REQUEST FOR INFORMATION

SUB2023-0031, DR2023-0018, CAP2023-0026, and SEP2023-0024

Project Location: 4193 Northwest AVE. Meridian Neighborhood, Area 2, zoned Residential Single Planned/Mixed, 3,600 square feet per unit for Infill Development Consistent with BMC 20.28.

Date of Notice: February 2, 2024

SHEET CONTENTS:
WETLAND BUFFER EXHIBIT

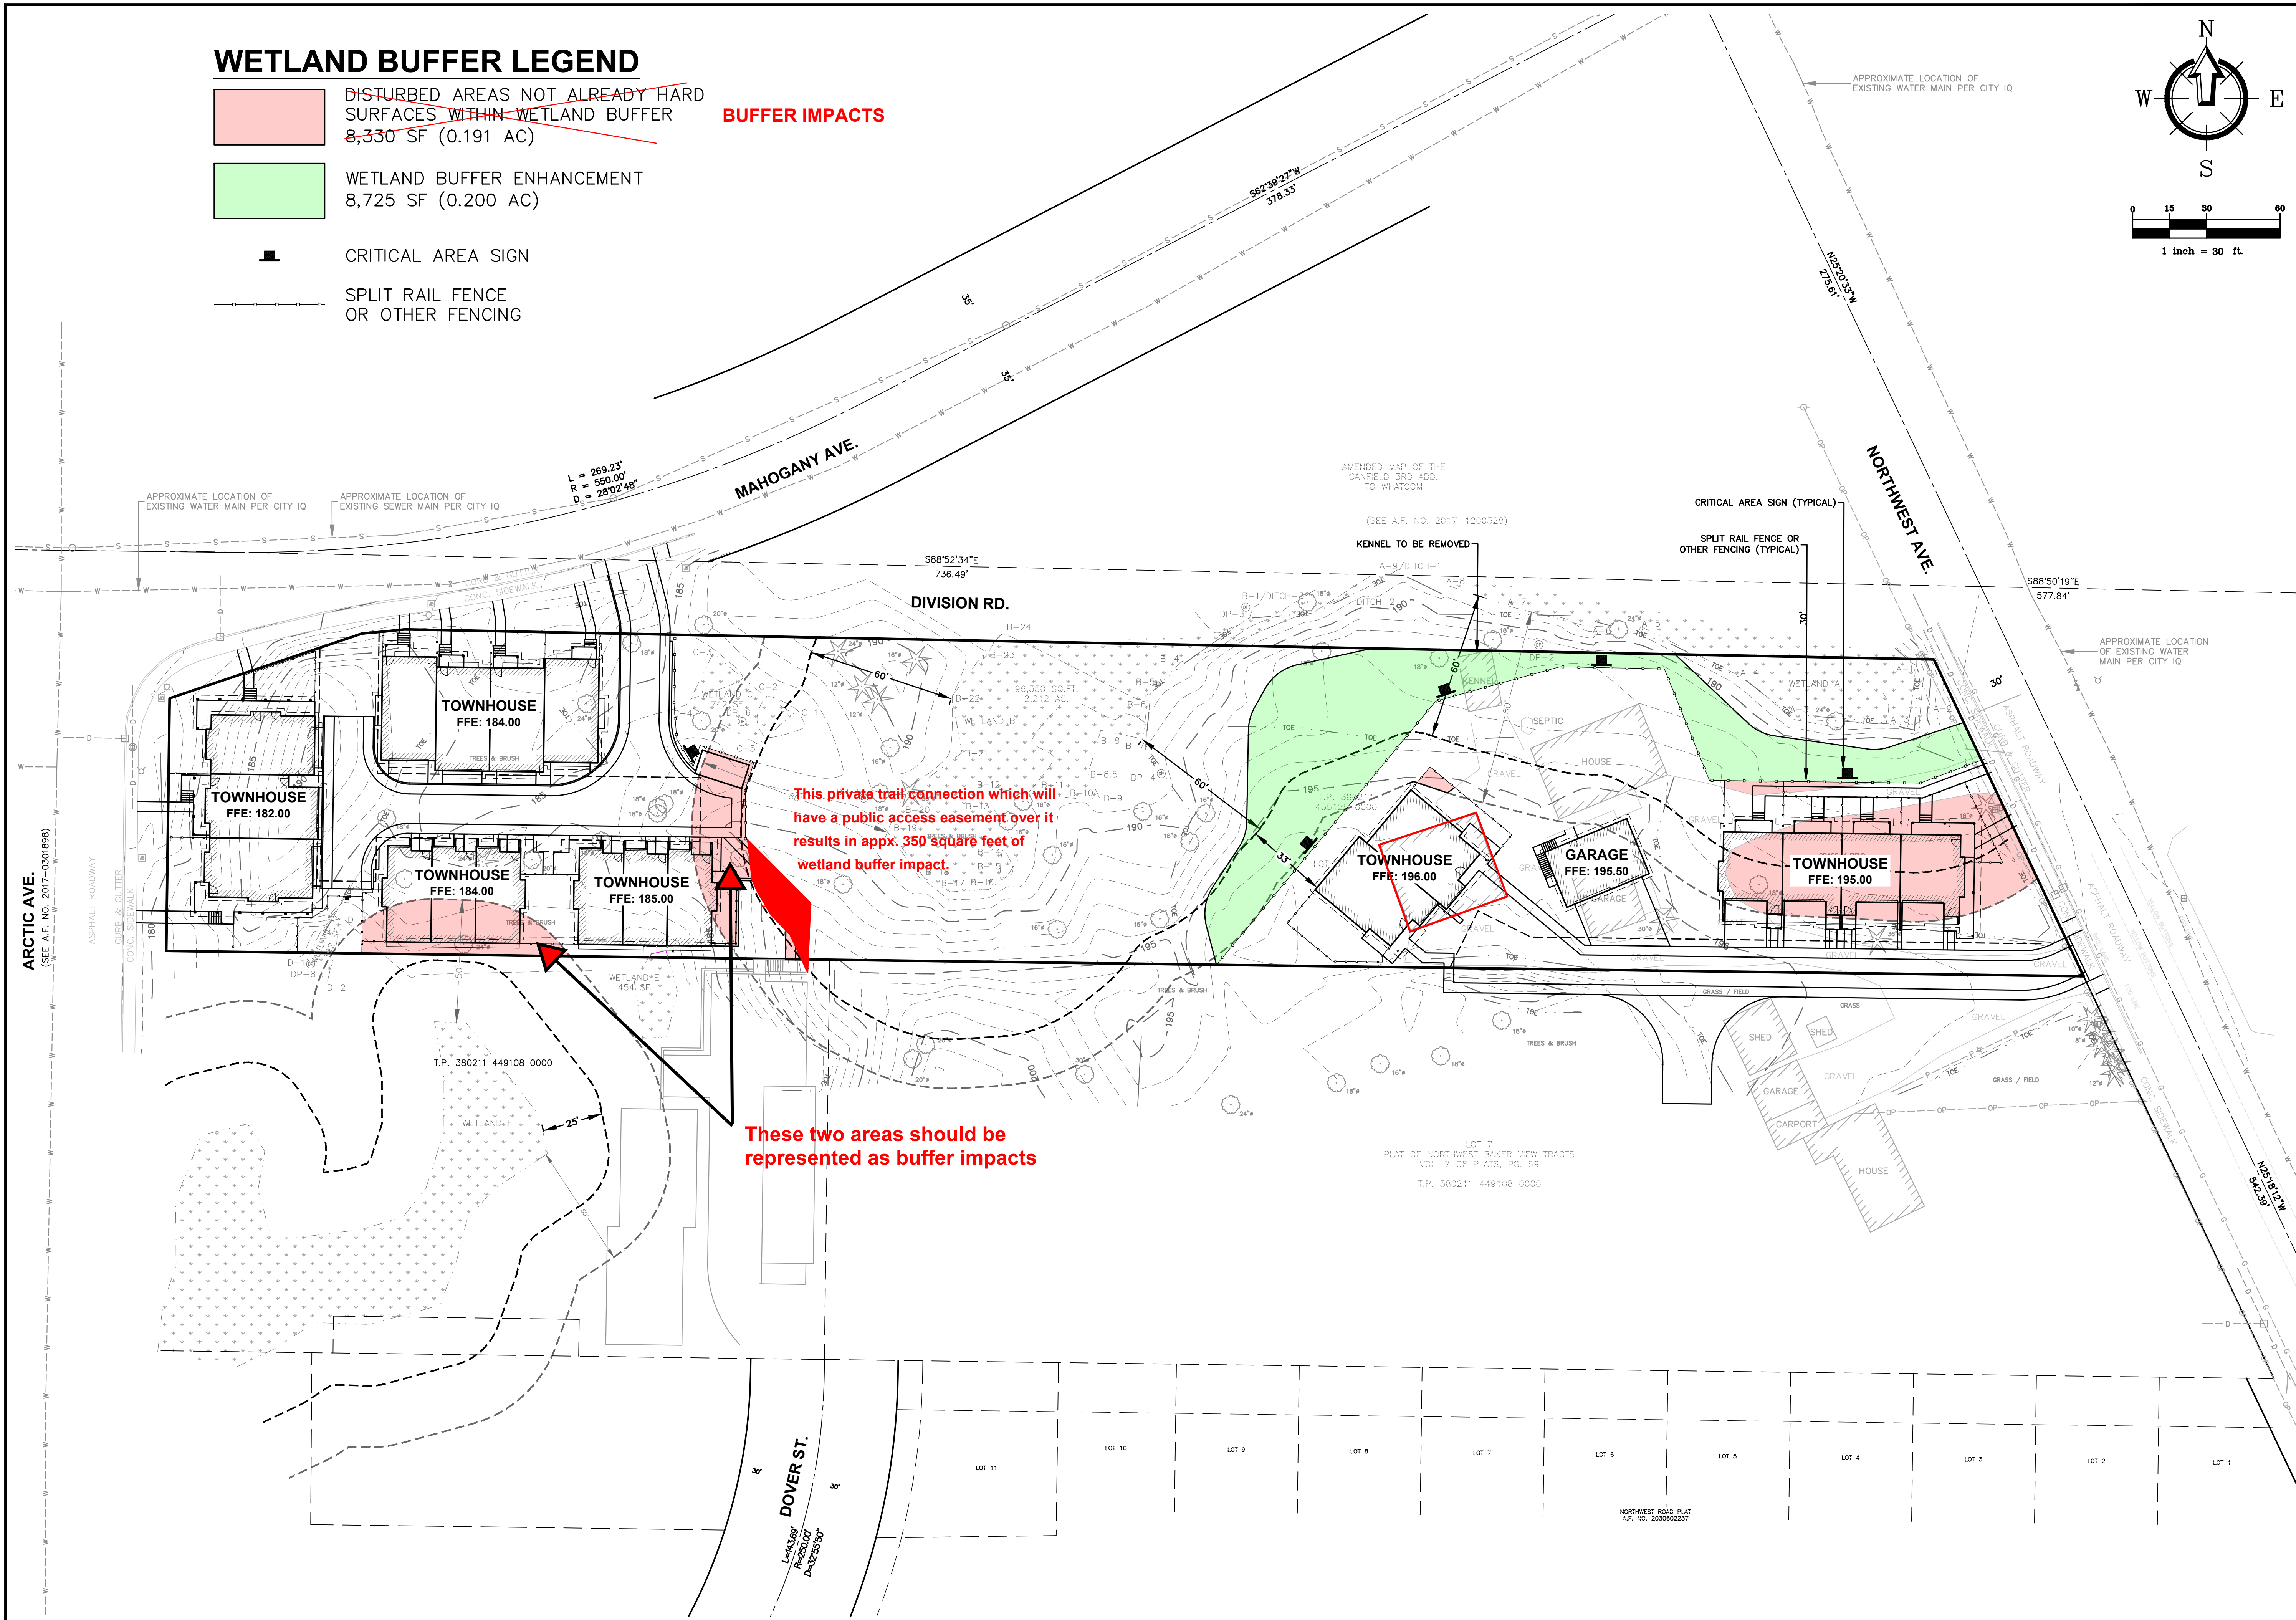
- a. **ACTION ITEM:** Revise the mitigation plan needs to account for the additional buffer impact associated with the trail element that will be constructed / maintained by applicant but have a public easement over the top of it. Refer to redlines on extracted sheet.
- b. **ACTION ITEM:** Revise the legend to show "wetland buffer impacts" instead of categorizing it as "disturbed areas not already hard surfaces." Refer to redlines on extracted sheet.

- ~~DISTURBED AREAS NOT ALREADY HARD SURFACES WITHIN WETLAND BUFFER~~ **8,330 SF (0.191 AC)** **BUFFER IMPACTS**
- WETLAND BUFFER ENHANCEMENT **8,725 SF (0.200 AC)**
- CRITICAL AREA SIGN
- SPLIT RAIL FENCE OR OTHER FENCING
